File MS-1996-021

Name: Grace Commercial Sub.- Minor Subdivision-Was West Side Of Faith Street Now Bogart Ln

# REVIEW COMMENTS

## **Petitioner's Response to Review Comments**

Grace Commercial SUBMISSION - ASBUILT Detention Pond

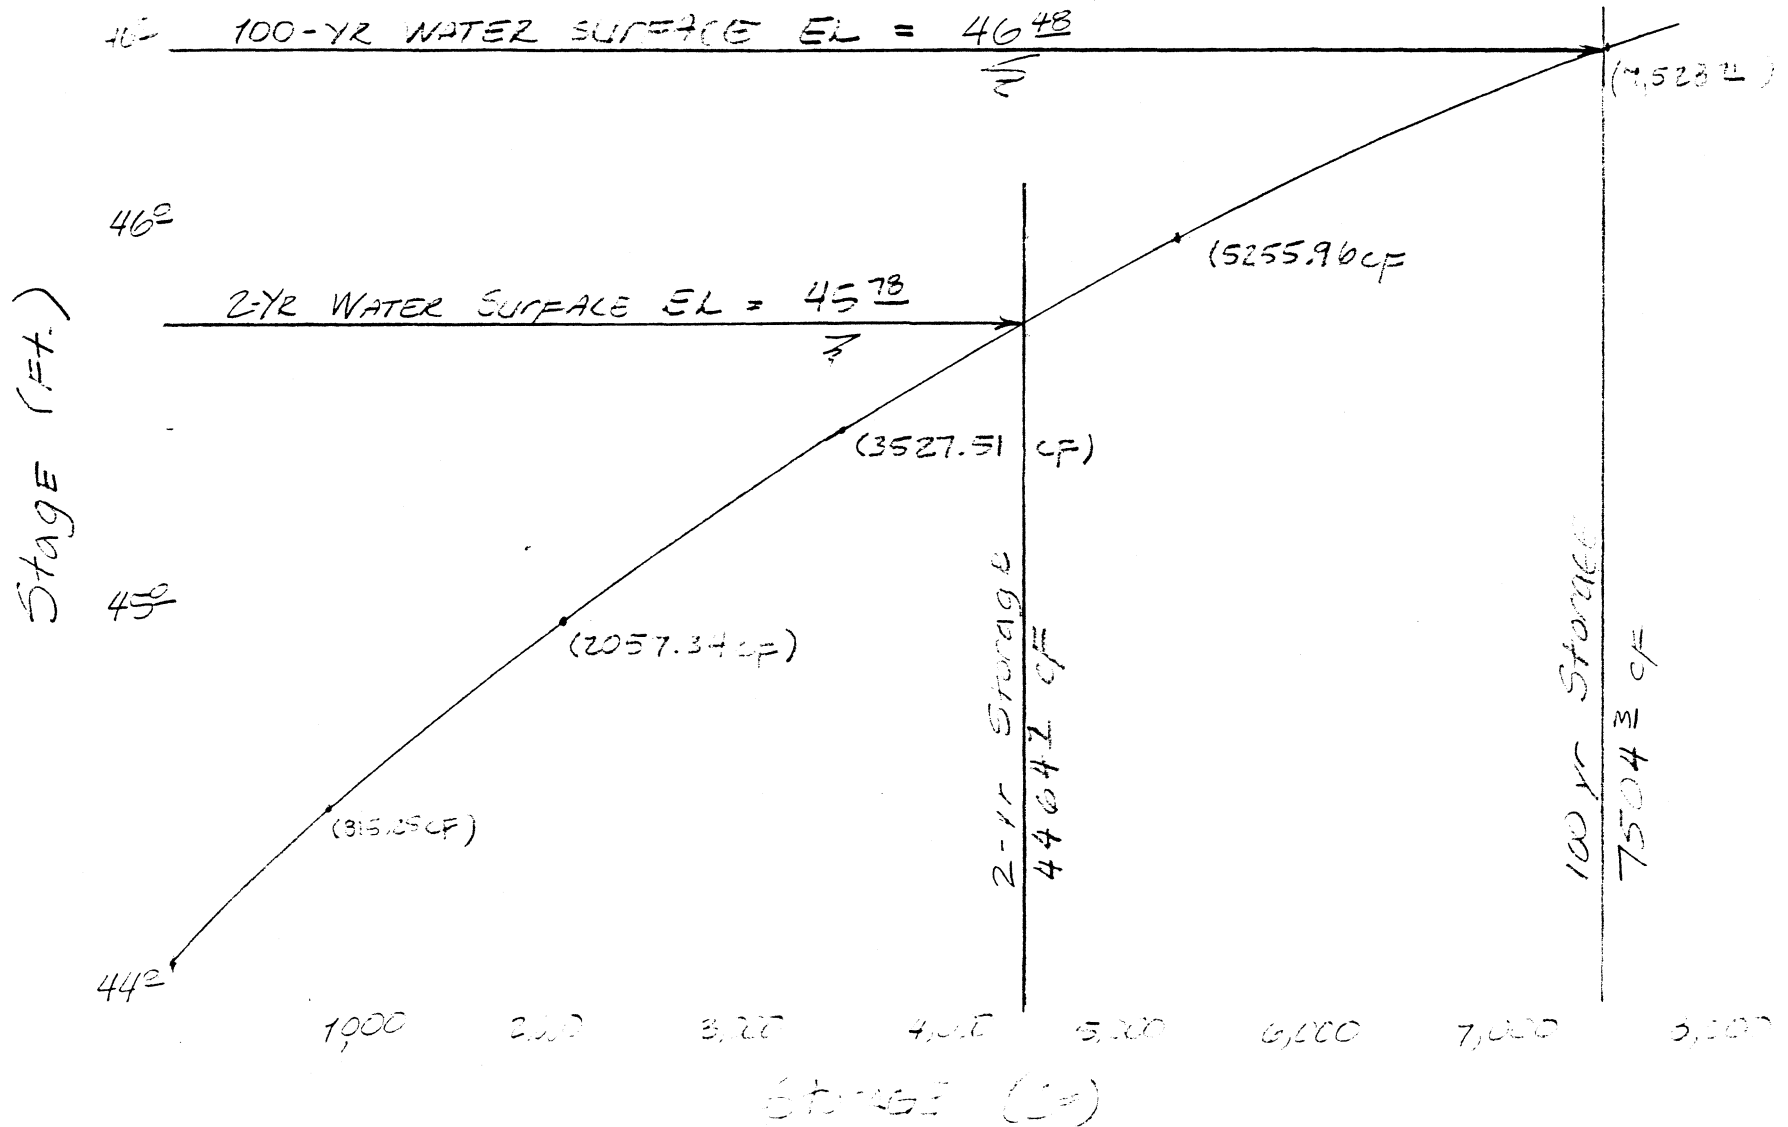
The facility was surveyed following construction on 3/26/97, but was found to have less volume than required by the design. The contractor reshaped the basin and had us resurvey it on 4/10/97 which did confirm that the basin slightly exceeded the required volume as shown on the attached drawing.

Please accept this letter as my certification that the detention facility at Grace Commercial Subdivision now meets the detention volume criteria called for in the project drainage study.
